Plan Change 7 Submissions
Freepost 172189
City Planning Unit
Hamilton City Council
Private Bag 3010
Hamilton 3240

Submission on Proposed Plan Change 7 – Rotokauri North Private Plan Change

Figure 15 -7a

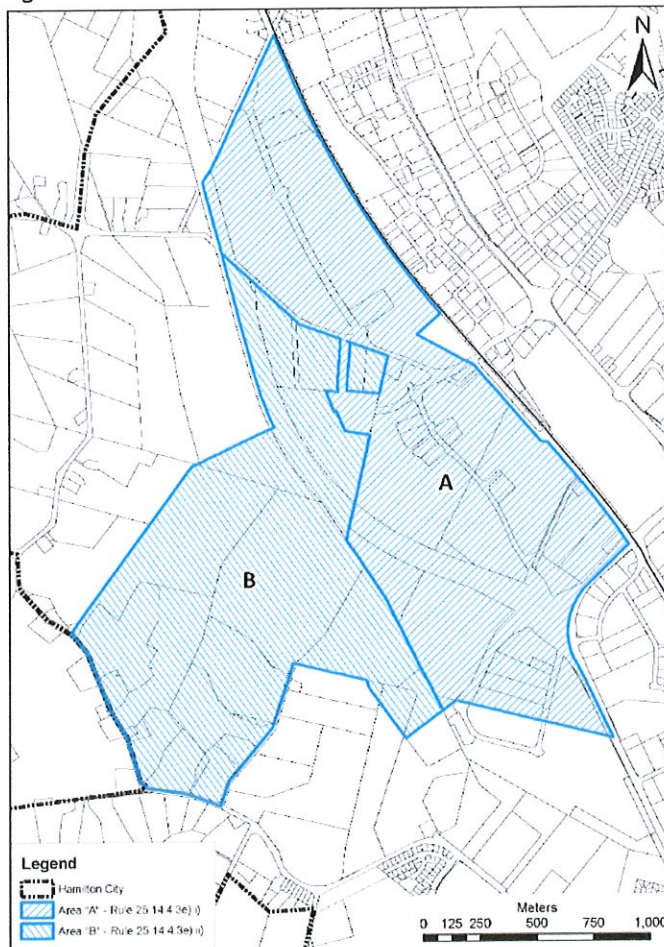
The proposed plan change is inconsistent with structure plan component *“3.6.3.2 Roding”* in its entirety. The proposed area is within the stage 2 area, outside of Areas A and B (see Figure 15-7a). The Rotokauri Structure Plan indicates that the release of land beyond stage 1A (such as the PPC): *“will be contingent upon the availability of network capacity which may arise as a result of traffic generation”* and 3.6.2.3 d and e) provide that:

Proposals for the development of land in ‘Area B’ on Figure 15-7a will require careful scrutiny to ensure that adequate network capacity exists to support the development, or will be provided as part of the development and they will not compromise the development of land in ‘Area A’ on Figure 15-7a. Development will require:

e) The development of land outside Areas 'A' and 'B' (Figure 15-7a) will need to coincide with the northwards extension of Rotokauri Minor Arterial Road to connect with Te Kowhai Road at the City Boundary.

The PPC is clearly contrary to these provisions, and the developer is trying to dodge the full cost of developing ahead of the planned sequencing by exempting itself from these Rotokauri Structure Plan provisions. The PPC does not provide adequate transport network capacity outside of the PPC area to support the proposed development. The proposal does not achieve a sustainable expansion of the city and does not represent coherent and integrated development, because the transportation effects beyond the Rotokauri North boundaries have not been resolved.

- Either decline the private plan change; or
- Decline proposed inclusion of section 3.6 d (exemption of PPC area from Rotokauri Structure Plan), but approve the development subject to requiring the developer to adhere to all existing Rotokauri structure Plan provisions, including:
 - a) requiring they construct the Rotokauri Minor Arterial Road;
 - b) provide an ITA that adequately assesses impacts on the wider transport network and have that ITA peer reviewed.
 - c) cater for the demand generated within the wider transport network;

- d) requiring the developer to fund all necessary road network upgrades and additions.
- e) provide a full economic assessment of the financial impact on the remainder of the Rotokauri Structure plan area and including the likely cost of the required roading upgrades.
